Re: Preliminary Determination of Compliance for the Salton Sea Unit 6
Power Plant Project

We represent the California Unions for Reliable Energy ("CURE"). CURE is a party to the Salton Sea Unit 6 Power Plant Project ("SSU6") proceeding before the California Energy Commission ("Commission"). We offer the following comments on the Preliminary Determination of Compliance ("PDOC") for the SSU6.

Figure 1

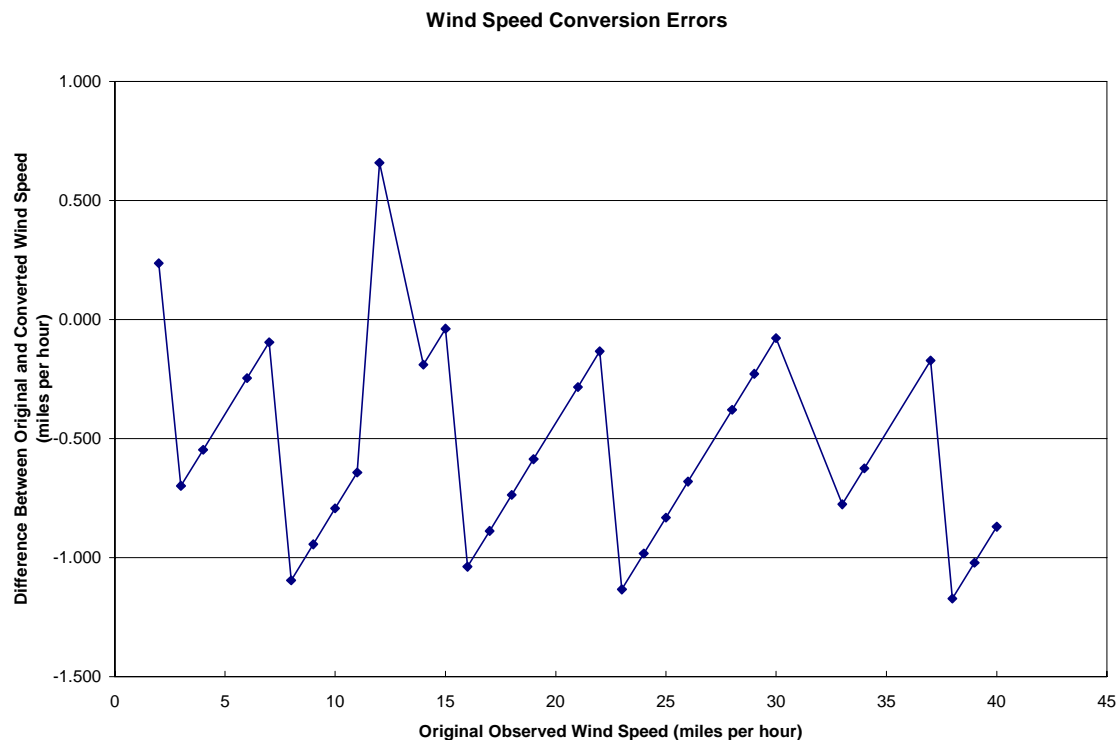
Clearly, the conversion factor should be the same regardless of wind speed. The peculiarity in the AFC's processed meteorological data cannot be readily explained, but varies with wind speed as shown graphically in Figure 1.

It is unclear why the wind speed conversions would vary or if they have been altered prior to converting from mph to m/s, but it is clearly incorrect. The applicant, in response to a Energy Commission data request, contends that National Climatic Data Center ("NCDC") rounding errors have caused the differences in originally observed and converted wind speeds (the NCDC data reflect a conversion from metric to English units). However, rounding errors cannot account for the magnitude of the differences observed when comparing the NCDC data to the meteorological data processed by the applicant. It is possible that the applicant made additional data conversions and rounding errors, but it is unclear why this would be done. At wind speeds of less than 10 mph, the applicant's wind speeds contain errors ranging from 1 to 23 percent compared to the NCDC data. If the NCDC data contains similar rounding errors, the wind speeds used in the dispersion modeling could be as high as 50 percent.
